# UNITED STATES PATENT AND TRADEMARK OFFICE

APPLICATION NO.	FILING DATE	FIRST NAMED INVENTOR	ATTORNEY DOCKET NO.	CONFIRMATION NO.
10/801,760	03/15/2004	Jozef C. Mitros	TI-35141.1	3452
23494	7590	06/06/2005		
TEXAS INSTRUMENTS INCORPORATED P O BOX 655474, M/S 3999 DALLAS, TX 75265			EXAMINER DOAN, THERESA T	
			ART UNIT	PAPER NUMBER
			2814

# Office Action Summary

## DETAILED ACTION

**FIG. 1**

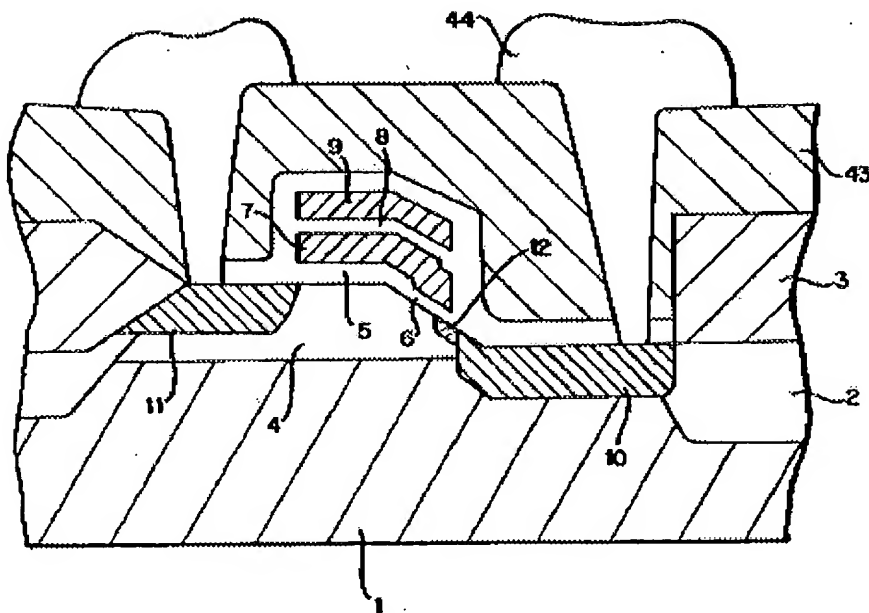
Regarding claims 10 and 13, Matsushita (figures 1-13) discloses a method of manufacturing a semiconductor device, comprising:

implanting source region (10,12) and drain region 11 having similar (N-type) doping profiles (see Figure 1, column 7, lines 50-53 and column 13, lines 55-59) in a semiconductor substrate 1 (column 13, lines 48-50) , thereby defining a channel region 4 (column 13, line 51) extending from the source region (10,12) to the drain region 11 (see figure 1);

locating a dielectric layer (5,6) over the source and drain regions (see figure 1), the dielectric layer (5,6) having a first thickness 5 (or 34) of about 15 to 20 nm (column 17, lines 27-28) and a second thickness 6 (or 33) of about 10 nm (column 17, lines 23-

24), wherein the second thickness 6 is substantially less than the first thickness 5 and is partially located over the channel region (see figure 13 and column 18, lines 31-40); and

forming a gate 7 (figure 1) or 35 (figure 13) over the dielectric layer (5,6) (column 17, lines 55-59), wherein the second thickness 6 is located between an end of the gate 7 and one of the source and drain regions (10,12).

Regarding claim 18, Matsushita further discloses that the gate 7 is a floating gate and further includes forming a control gate 9 over the floating gate 7 (column 13, lines 53-55).

FIG. 13

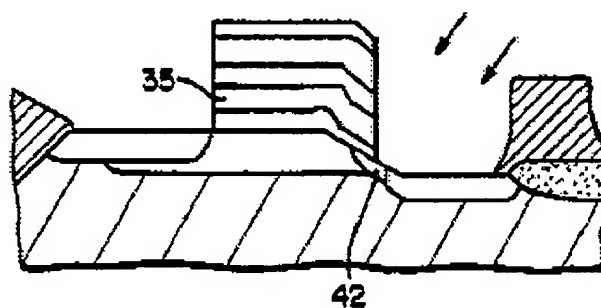
However, Matsushita (figure 13) teaches the forming of a lightly doped region 42 in the source/drain regions (column 18, lines 31-36), the lightly doped region 42 having the doped concentration of about  $1.0E18$  atoms/  $cm^3$  or less (column 18, lines 41-43).

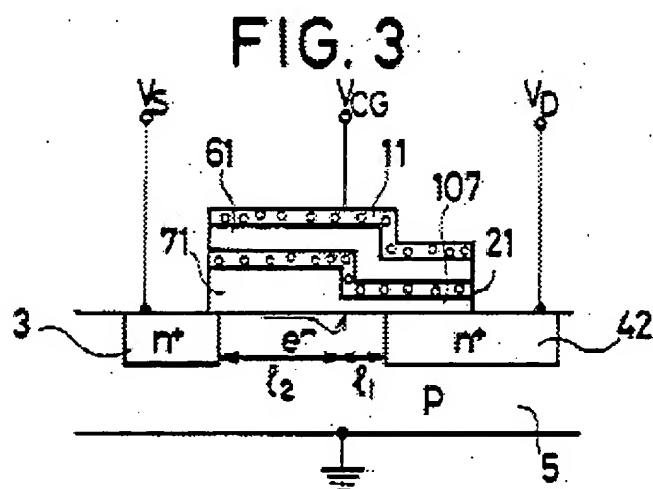
Regarding claims 10 and 13, Kamiya (figure 3) discloses a method of manufacturing a semiconductor device, comprising:

implanting source region 3 and drain region 42 having similar (N-type) doping profiles (column 2, lines 42-47) in a semiconductor substrate 5 (column 2, line 44), thereby defining a channel region ( $I_2, I_1$ ) extending from the source region 3 to the drain region 42;

locating a dielectric layer (71,107) over the source and drain regions (3,42), the dielectric layer (71,107) having a first thickness 71 and a second thickness 107, wherein the second thickness 107 of 80Å (column 4, lines 50-52) is substantially less than the first thickness 71 of 800Å (column 3, lines 14-15) and the second thickness 107 is partially located over the channel region (see figure 3 and column 2, lines 52-54); and forming a gate 21 over the dielectric layer (71,107) (column 2, lines 66-67), wherein the second thickness 107 is located between an end of the gate 21 and one of the source and drain regions 42.

Regarding claim 14, Kamiya (figure 3) further discloses that the locating includes an interface between first and second layers (71,107) of the dielectric layer by forming the second layer 107 on the channel region portion I<sub>1</sub> and the first layer 71 on the remaining channel region portion I<sub>2</sub> (column 2, lines 48-57).

Regarding claim 18, Kamiya (figure 3) further discloses that the gate 21 is a floating gate and further including forming a control gate 11 over the floating gate 21 (column 2, lines 66-68).

**FIG. 1**

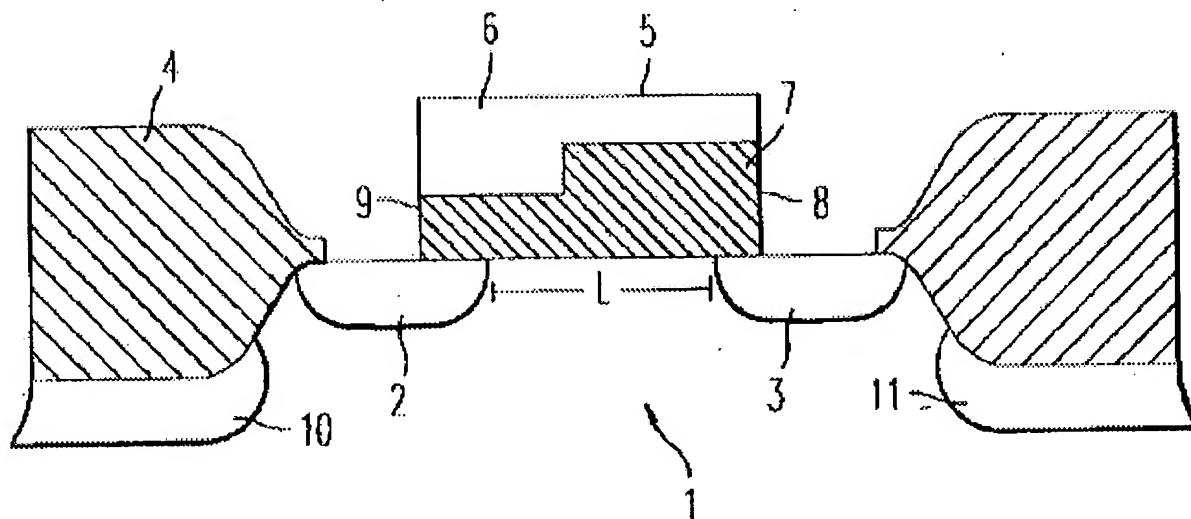
Regarding claim 10, Kachelmeier (figure 1) discloses a method of manufacturing a semiconductor device, comprising:

implanting source region 2 and drain region 3 (column 3, lines 45-55) having similar (N-type) doping profiles in a semiconductor substrate 1 (column 8, lines 1-3) , thereby defining a channel region (L) extending from the source region 2 to the drain region 3;

locating a dielectric layer (8,9) over the source and drain regions (2,3), the dielectric layer (8,9) having first thickness 8 and second thickness 9 wherein the second thickness 9 is substantially less than the first thickness 8 (column 2, lines 49-54) and the second thickness 9 is partially located over the channel region (see figure 1, column 2, lines 49-54); and

forming a gate 6 over the dielectric layer (8,9) (column 2, lines 37-38), wherein the second thickness 9 is located between an end of the gate 6 and one of the source and drain regions (2,3).

Regarding claims 12-13, Kachelmeier further discloses that the first thickness 8 ranges about 25 nm to about 50nm and the second thickness 9 ranges about 6nm and about 20nm as claimed (column 2, lines 49-54).
